ADDENDUM NO. 4

Tasmania Court Water Main Extension

CITY OF HOMER, ALASKA

Addendum Issue Date:	<u>October 7, 2021</u>	
Bid Submittal Date:	<u>November 23, 2021</u>	
Previous Addenda Issued: Issued By: Janette Keise Public Works City of Homer	r, PE Director

Site Map

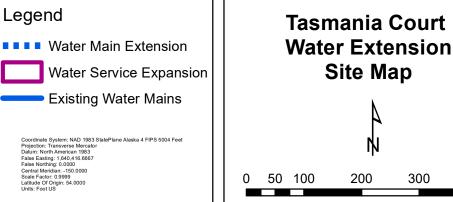
Question #6: Is ground water expected to be encountered digging in this area?

Answer #6: The City made test wells to check groundwater levels on September 6, 2021. One test well was made on South Slope Rd., another on Tasmania Ct. West and a third on Tasmania Ct. East. The test well on South Slope Rd. was dry, the one on Tasmania Ct. West found groundwater at 5' below the surface and the one on Tasmania Ct. East found groundwater at 6' below the surface. An updated site map has been attached to show the locations and depths of the test wells.
